Important Notice

From 1st of November 2010, Pascal has changed the way of piping connection for the following models, specifically using the pipe thread.

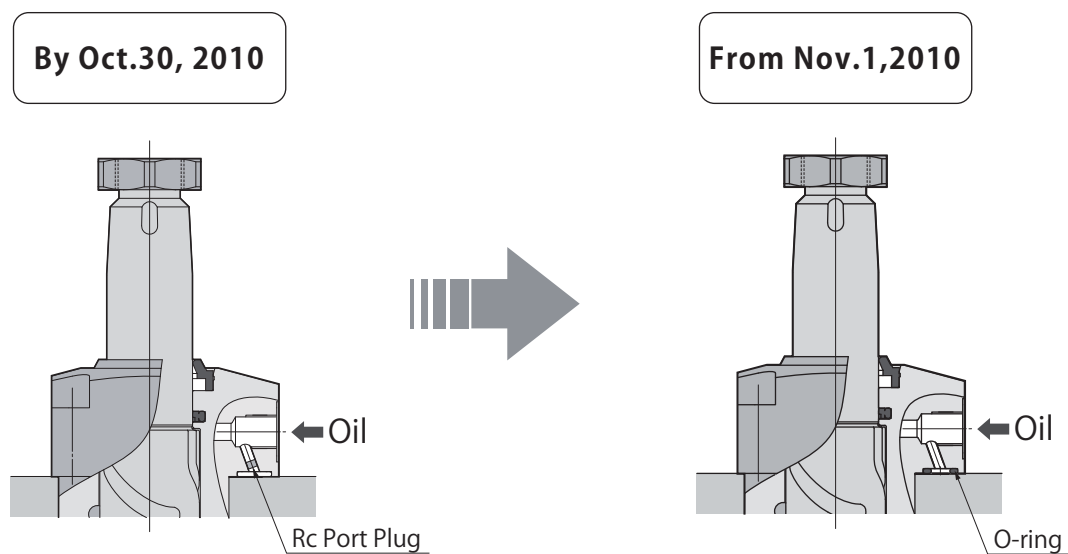
Plug the o-ring port with Rc port plug
after removing the o-ring and G port plug.
(Rc port plugs are packed with the clamp)

O-ring seals the port instead of Rc plug.
Do not remove the o-ring initially
mounted with the clamp.

Please ask Pascal for a solution in case of the following condition of mount.

It may cause oil leakage due to the sealing incompleteness.

- O-ring cannot seal the oil because O-ring port get in the sealing way.
- There is no sealing surface by O-ring.
 - ex : Mounting with square spacer block.
 - : Mounting with levelling block. (4 pcs of pipe)

In case a flow control valve is mounted on pipe thread, it have to be removed to another location.
